**CITY OF DOVER PLANNING COMMISSION
AGENDA**

Monday, March 18, 2019 – 7:00 P.M.

**City Hall, City Council Chambers
15 Loockerman Plaza, Dover, Delaware**

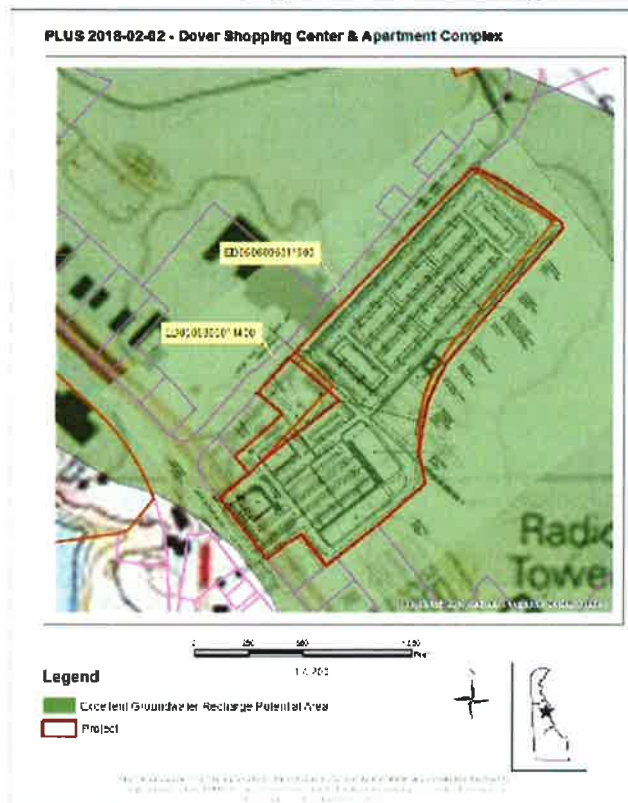
Excellent Ground-Water Recharge Areas are those areas mapped by the Delaware Geological Survey where the first 20 feet of subsurface soils and geologic materials are exceptionally sandy. These soils are able to transmit water very quickly from the land surface to the water table. This map category (excellent) is an indicator of how fast contaminants will move and how much water may become contaminated (Andres, 2004).

Land use activities or impervious cover on areas of excellent ground-water recharge potential may adversely affect ground water in these areas.

The City of Dover has a source water ordinance in place with conditions for development within areas of excellent groundwater recharge potential. Section 29.7 regulates development in areas of excellent recharge. The Section requires reduction of impervious surfaces for redevelopment and limits impervious cover for new construction. This project does not appear to meet the requirements of the City of Dover's Source Water Protection Overlay Zone requirements.

- DNREC recommends review by the City of Dover and adherence to the City of Dover's Source Water Protection Overlay Zone requirements.
- In addition, because the excellent ground water recharge area can readily affect the underlying aquifer if contaminants are spilled or discharged across the area, the storage of hazardous substances or wastes should not be allowed within the area unless specific approval is obtained from the relevant state, federal, or local program.
